ATTACHMENT (1)

CALVERT CLIFFS UNIT 1
SFP CRITICALITY ANALYSIS

UNIT 1 SPENT FUEL POOL ENRICHMENT LIMIT WITH SOLUBLE BORON CREDIT

CA06011 REVIEW COMMENTS from J.R. Massari

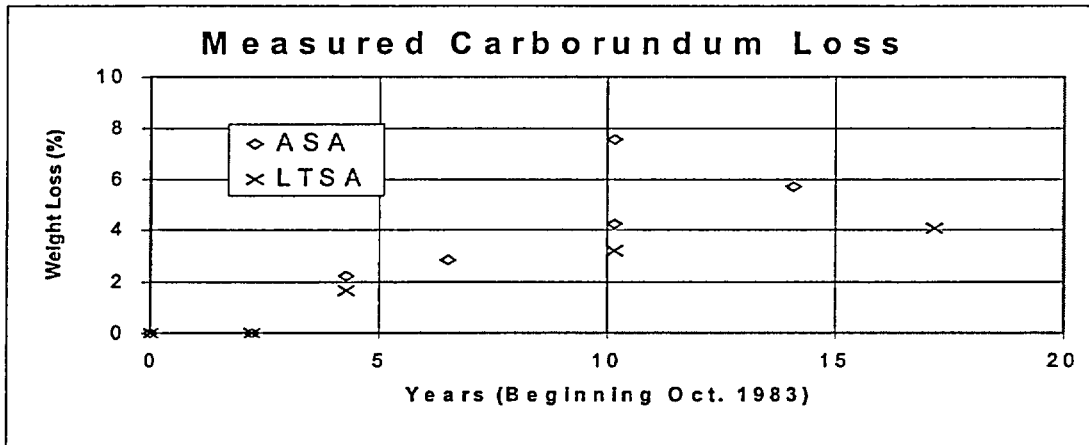
Section 9 B.7. The calculation uses a 26.2% boron loss (0.024 to 0.0177 g/cm²) over the life of the spent fuel pool racks. This is a conservative assumption based on the measured data.

ETP 86-03, "Analysis of Neutron Absorbing Material in the Spent Fuel Storage Racks," provides direction for long term surveillance of the neutron absorption material samples in both spent fuel pools' racks. The samples are in two different sample assemblies: an Accelerated Surveillance Assembly (ASA) and a Long Term Surveillance Assembly (LTSA). After each refueling, freshly discharged fuel assemblies surround the ASA samples. ETP 86-03, revision 3 contains the following measured data of carborundum loss:

Except for the obvious anonymous data, the ASA shows a very linear trend of 0.414% loss per year. Using this ASA data, this results in a conservative service life of 63 years (26.2% allowable loss ÷ 0.414% loss per year) for the carborundum. The Unit 1 spent fuel pool racks were installed in 1983. Based on the carborundum loss, the service life of 63 years ends in 2046. This exceeds the requirement for a service until 2044. (Unit 1 license expires in 2034 plus 10 years of decommissioning).

Response OK
